Access Compliance Report

Public Rights-of-Way

(Curb Ramps)

Intersection ID: 53804	Main Street: NATHAN_DR	Cross Street: PITZER_DR	Location:	E
ADA ID: A1C7BF4CD64E	Ramp Type: Perp	Initial Pass/Fail: Fail	Overall Compliance: No	Severity Score: 25
Codes/Mitigation Info/Possible Solution		Field Measurements/Component Compliance

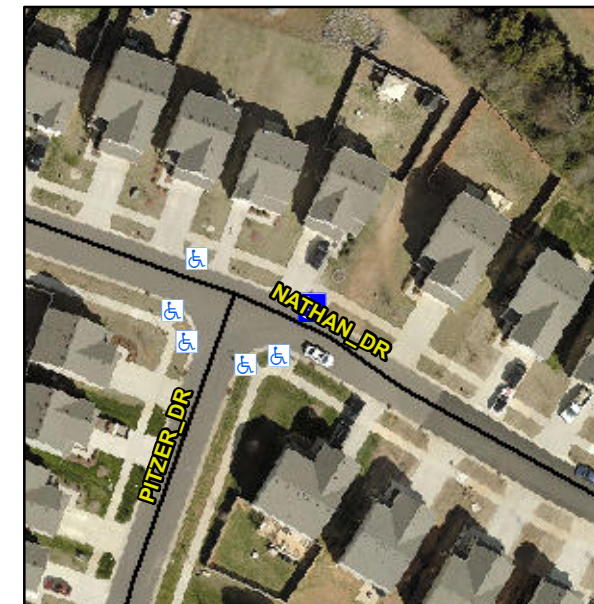
Not Found, R304.2.2

Compliance	Description	Data	Compliance	Description	Data
N/A	Ramp Length (in)	94.5	No	Ramp Slope (%)	16.5
Yes	Ramp Width (in)	60.0	Yes	Ramp XSlope (%)	0.9
N/A	Flare Type LT	N/A	N/A	Flare Type RT	N/A
N/A	Flare Slope LT (%)	N/A	N/A	Flare Slope RT (%)	N/A
N/A	Flare Traversable LT?	N/A	N/A	Flare Traversable RT?	N/A
N/A	Landing Length (in)	N/A	N/A	DWS Provided?	N/A
N/A	Landing Width (in)	N/A	N/A	DWS Contrast?	N/A
N/A	Landing Slope (%)	N/A	N/A	DWS Length (in)	N/A
N/A	Landing X Slope (%)	N/A	N/A	DWS Full Width?	N/A
N/A	Landing Curb? (Y/N)	N/A	N/A	DWS Offset (in)	N/A
N/A	Shared Landing?	N/A			
N/A	Gutter Ponding?	N/A	N/A	Gutter Slope (%)	N/A
N/A	Gutter Lip Ht (in)	N/A	N/A	Gutter X Slope (%)	N/A
N/A	Painted X Walk1?	No	N/A	Painted X Walk2?	N/A
	X Walk 1 Direction	To SW		X Walk 2 Direction	N/A
N/A	X Walk 1 Width (in)	N/A	N/A	X Walk 2 Width (in)	N/A
	X Walk 1 Slope (%)	4.1		X Walk 2 Slope (%)	N/A
	X Walk 1 X Slope (%)	2.7		X Walk 2 X Slope (%)	N/A

Remove & Replace Entire Ramp.
